III. CORRECTIONS AND ADDITIONS TO THE DRAFT EIR

A. CHANGES TO THE PROJECT DESCRIPTION

This chapter presents minor changes to the Draft EIR since the publication of the Draft EIR. Changes involve corrections and additions that have been made to clarify, correct, or add to the environmental impact analysis for the Draft EIR. Changes to the Draft EIR derive either from public and agency comments, from additional information desired by the Lead Agency since publication of the Draft EIR, or changes required by mitigation measures of the DEIR. Changes initiated by the Lead Agency include minor revisions to clarify the project description and to refine Alternative C. The changes do not affect the conclusions of the Draft EIR.

Revised Figure III-16 of the FEIR

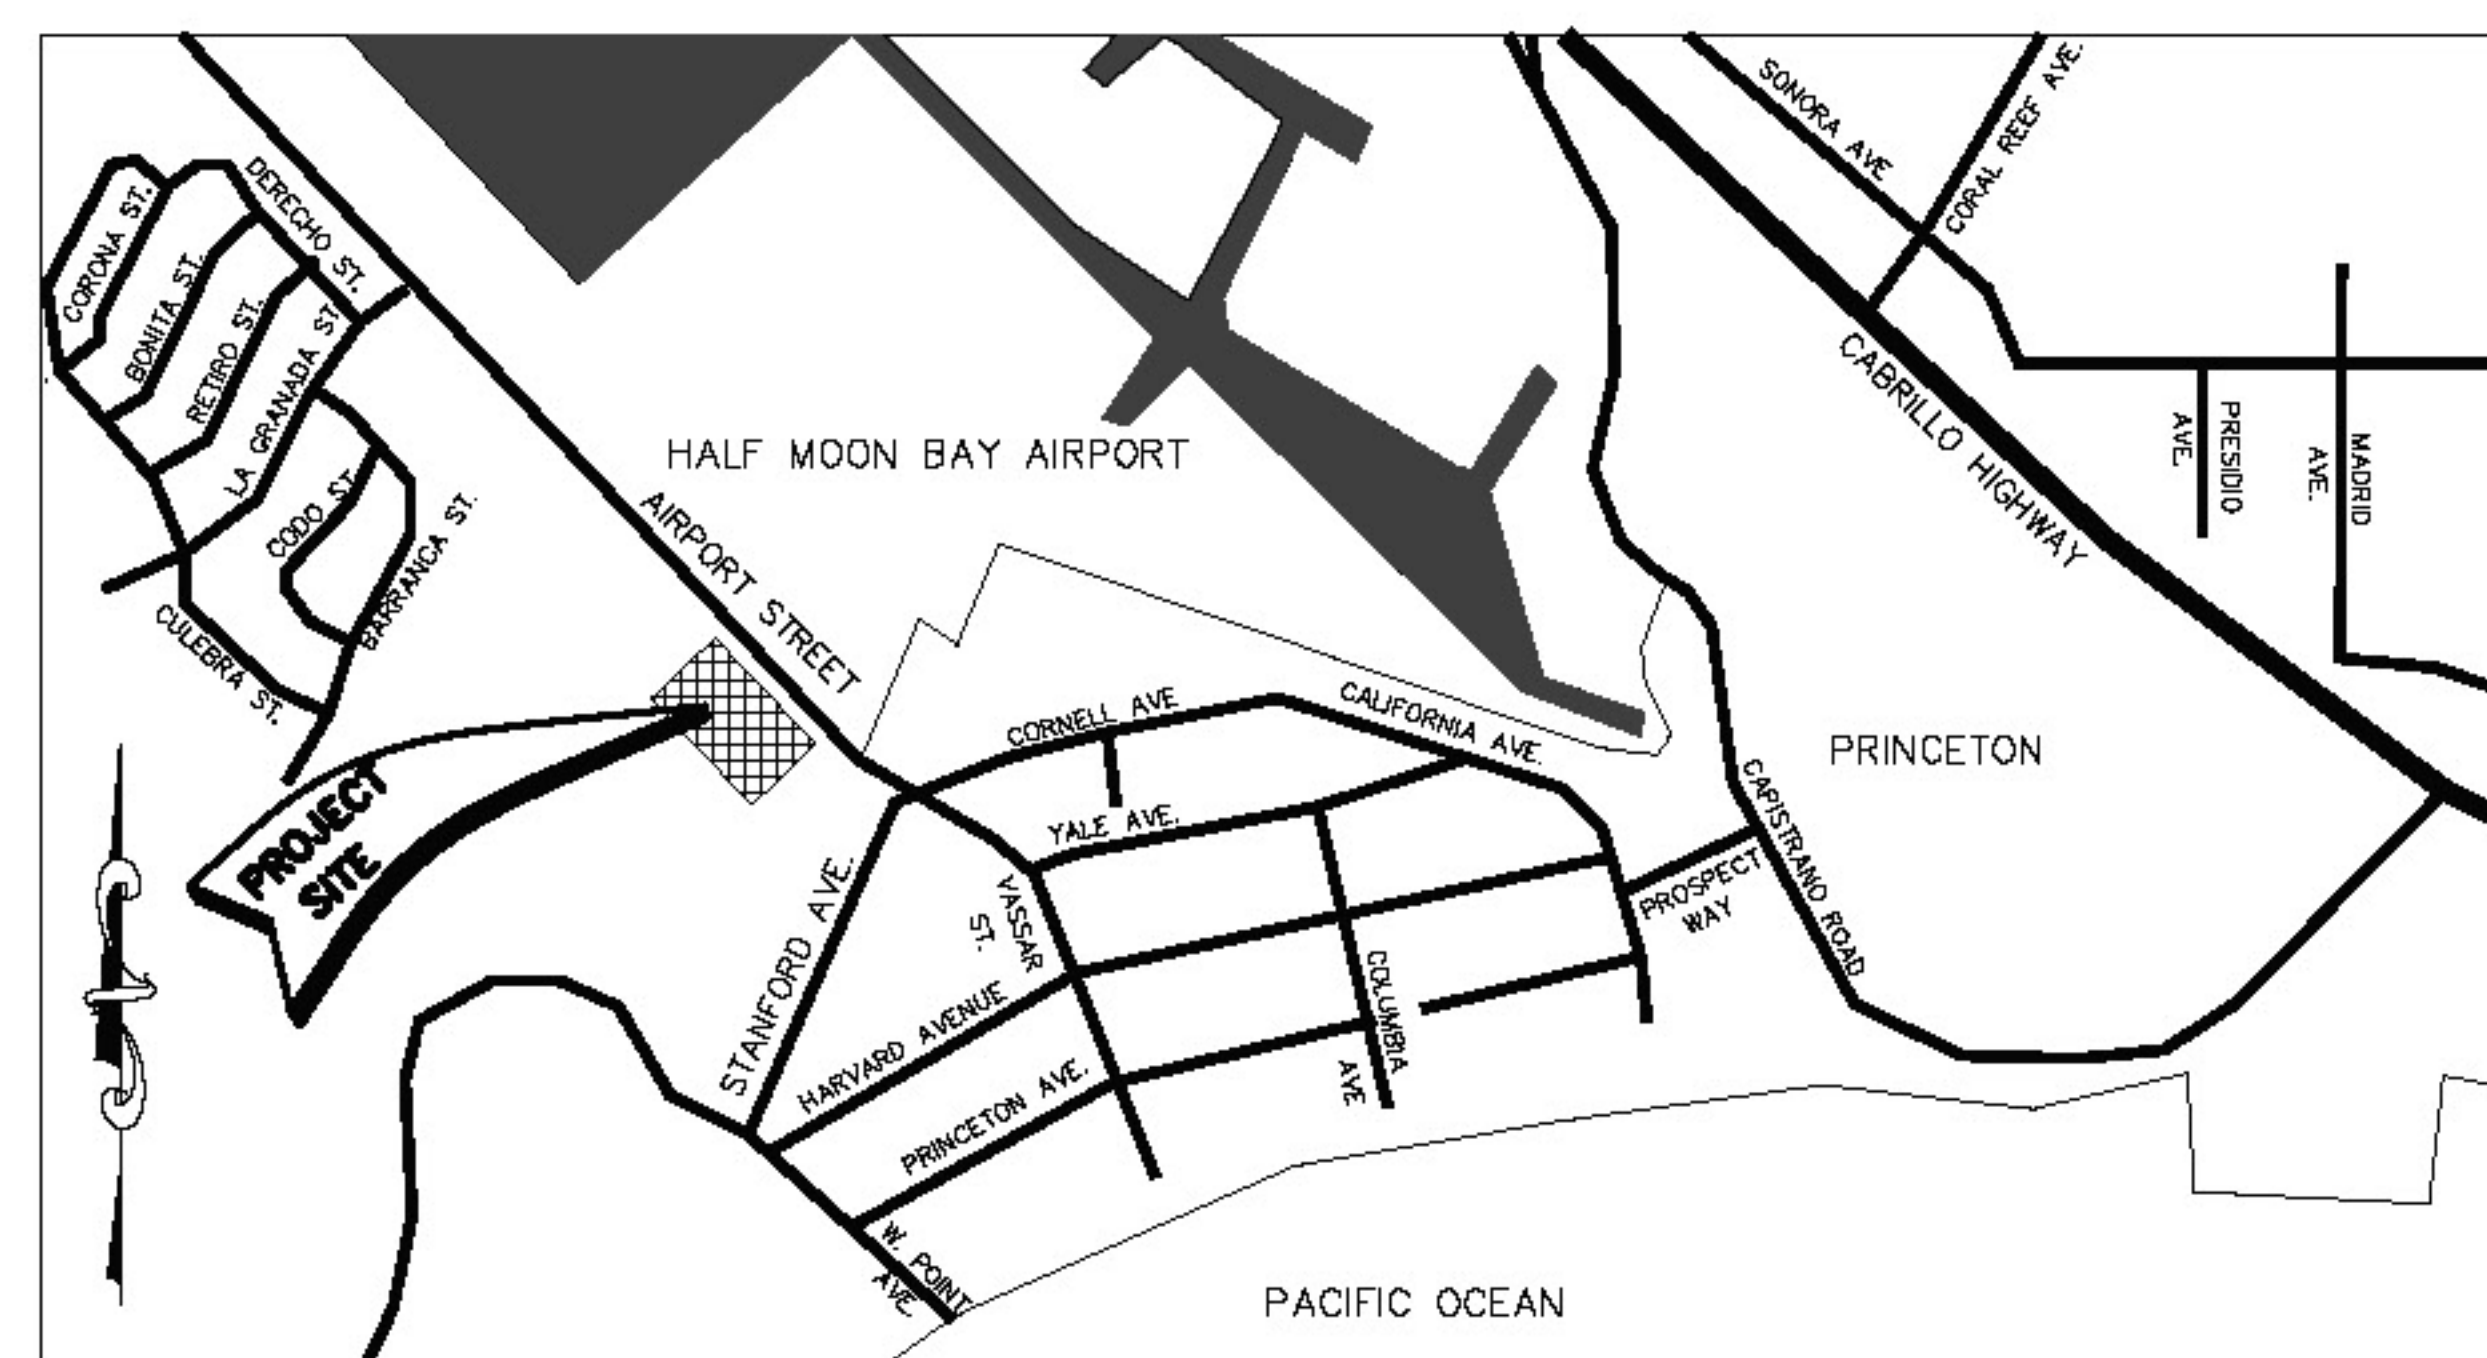
- REVISED Figure III-16 (Wellness Center Site Plan): The site plan for the Wellness Center has been revised to comply with Mitigation Measure CULT-2 and Mitigation Measure HYDRO-9. It should be noted that Figures III-17 through III-20 are still relevant to the project.
- REVISED Figure III-23 (Office Park Property Planting Plan): This figure has been revised to reflect uplands planting proposal.
- REVISED Figure III-24 (Wellness Center Property Planting Plan): This figure has been revised to reflect uplands planting proposal.
- REVISED Figure III-27 (Water Treatment Plant): This figure has been revised to reflect a modular wastewater treatment system
